## Q5.1 - References

- Comment:
  - This report relies on previous work and references to academic work. It is not complete in itself, such that member of the public would be able to review the report and understand the theoretical bases for the approach proposed. Please complete or expand references.
- Response
  - Two reports on which the report is based have been provided
    - EPRI report on LSST array study including mathematical background
    - Unpublished report on site effects on coherency

### Q5.4 LSST Coherency Residual at 6m Depth

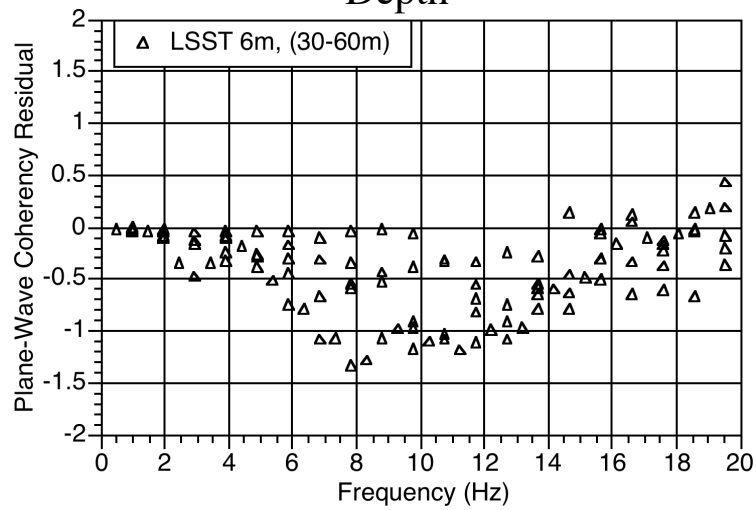
- Comment
  - The dense array data are from surface recordings.
    - (a) Are there any recordings at depth?
    - (b) If so, how is the energy distribution of the motion at depth and at surface?
    - (c) How is the coherency between adjacent records at depth developed?

- Compare computed coherency at depth with the model
- Compute residuals (positive residuals means under-prediction)
- Residual is averaged over each earthquake
- Only used data that was previously compiled
  - LSST - 5 eqk
  - Chiba - 3 eqk
  - EPRI Parkfield - 2 eqk
  - Other data from Chiba and LSST could be added
  - Data from other arrays could be added (Garni)

## Q5.7 Mag dependence Coherency Residual 8-12 Hz

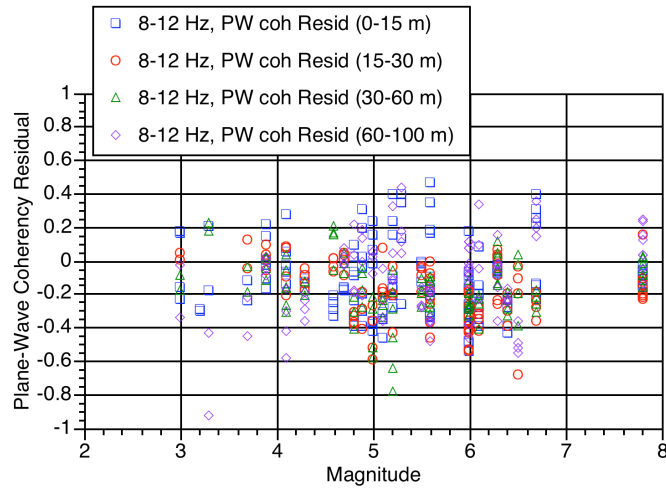
- Comment:
  - It is recognized in the report that topography influences amplification of ground motion at higher elevations. The extent to which magnitude, depth, local geology and directivity of ground motion propagation influence coherency of vibratory ground motions recorded within distances comparable to the foundation dimensions of a nuclear plant structures is not clear. Please document the cases.

- Response
  - Earthquake magnitude, focal depth, local geology, and directivity affect the amplitude of the ground motion but coherency is influenced by complex wave propagation due to scattering in the site region.
  - Residuals
    - Original Figures 3-4, 3-5 with respect to old model
      - Residuals corrected in Report
    - Magnitude, distance dependence checked with residuals
    - Directivity dependence cannot be checked with this data

Figure II-1. Comparison of the coherency decay recorded at the LSST array (event 12) and the SMART-1 array (event 43) (from Abrahamson *et al.*, 1991)

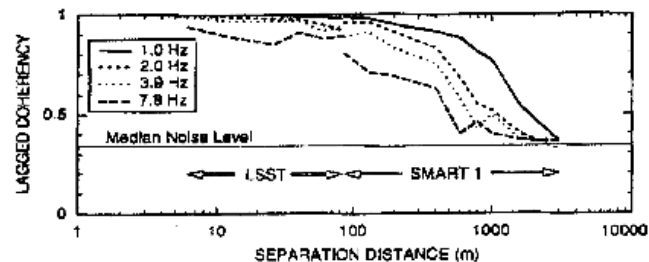
Can a single expression for the coherency reasonably represent the different exponential decay observed at long and short separation distances?

- Response:
  - There is a difference in the separation distance scaling at short and large distances.
    - Should not use scaling of low frequencies at large separation distances as a proxy for high frequencies and small separation distances
  - We used empirical recordings to constrain the scaling at short separation distances

## Q5-17 (b) Hollister Array

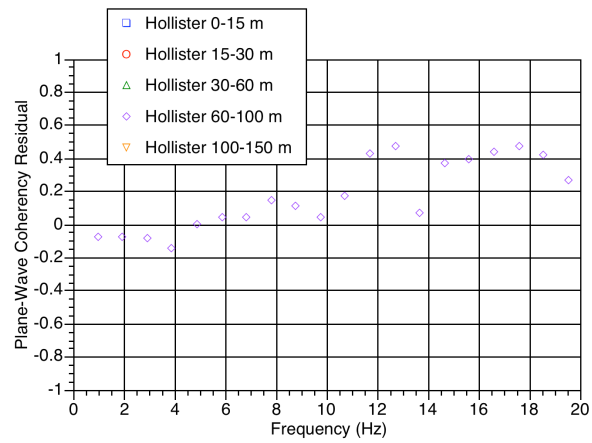
- Comment:
  - Since the number of soil arrays/events is significantly higher than that of the rock arrays/events, can it be that the trend in the data at the rock sites is "buried" within that of the soil sites?
- Response:
  - The plane-wave coherency residuals shown in the report are dominated by soil sites. The basis for combining these data is given in the unpublished report discussed above. The report has been modified to show the residuals separately for each array in figures 3-4a-h.

## Q5-18

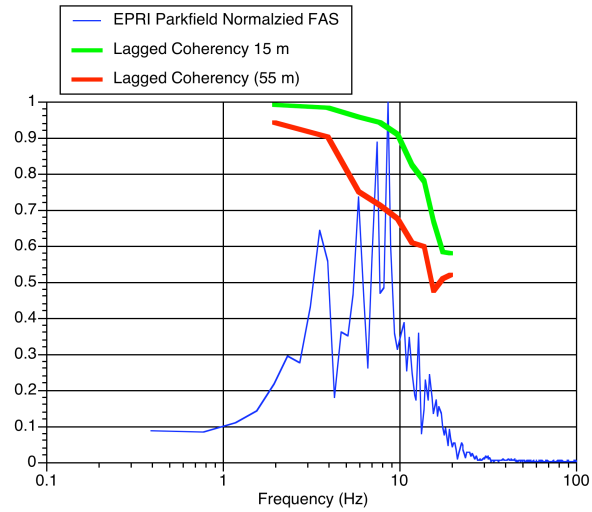
- The plane-wave coherency in Fig. II-9 decays sharply past the dominant frequency range of the soil PSD. However, it decays sharply from the beginning of the dominant frequency range of the rock PSD. Does this imply that a very significant part of the dominant frequency range of the rock sites cannot be considered as a single inclined wave but energy coming from different paths?

- For EPRI Parkfield, the coherency decays as the FAS increases

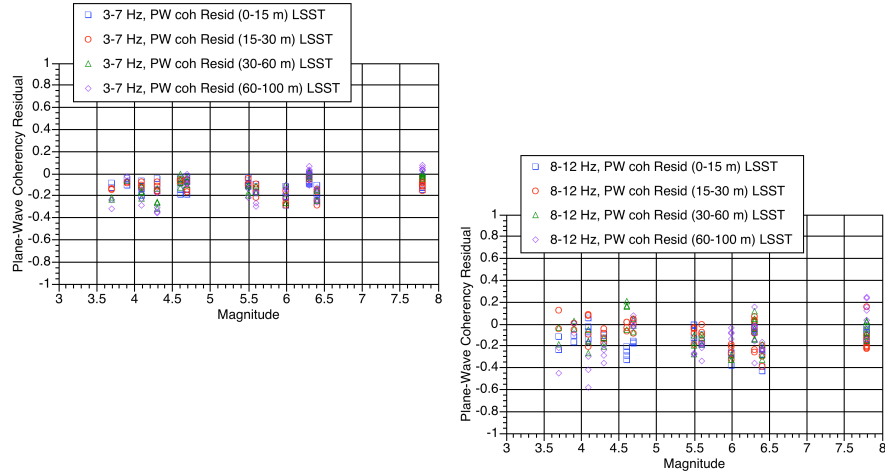
- Comment:
  - What is the number of earthquakes used and how many records were used for each array and earthquake?
- Response:
  - See Table

- Comment:
  - Provide clarification on the number of stations with separation distances equal to or less than 150 meters.
- Response:
  - See Table

## Q4.58 - Mag Dependence Chiba

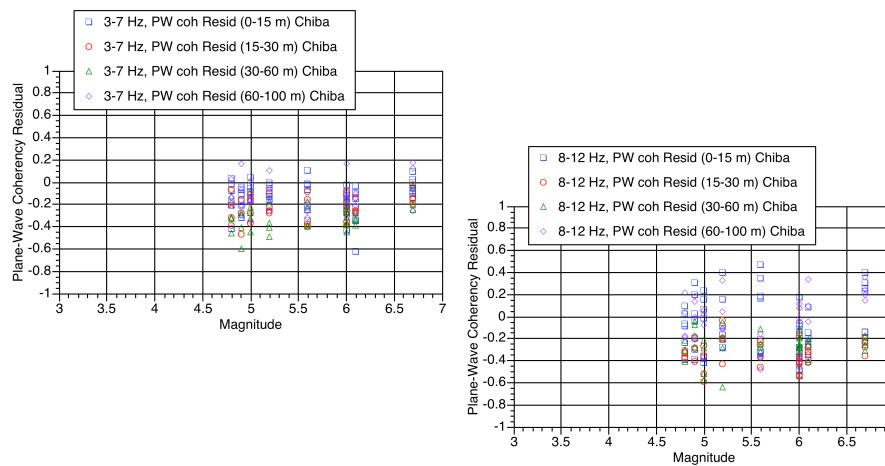
- Comment:
  - Provide a comparison of the coherencies obtained for different magnitude events at the same or comparable sites.
- Response:
  - Mag dependence of residuals is shown for the LSST array and for the Chiba array

## Q4-61 - Chiba Residuals

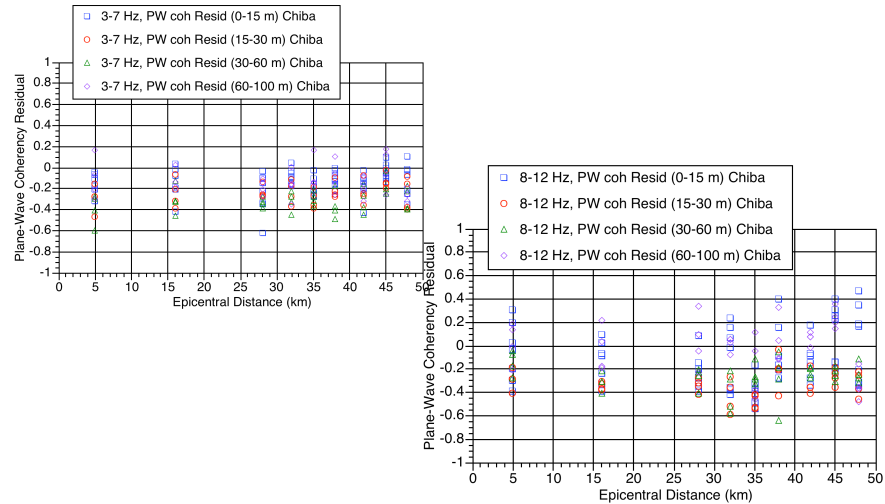
- Comment:
  - Please explain the basis for claiming independence of source-to-site distance on coherency.
- Response:
  - The basis is the plot of the residuals vs distance.
  - We have plotted the residuals for the LSST and Chiba arrays separately in the following plots
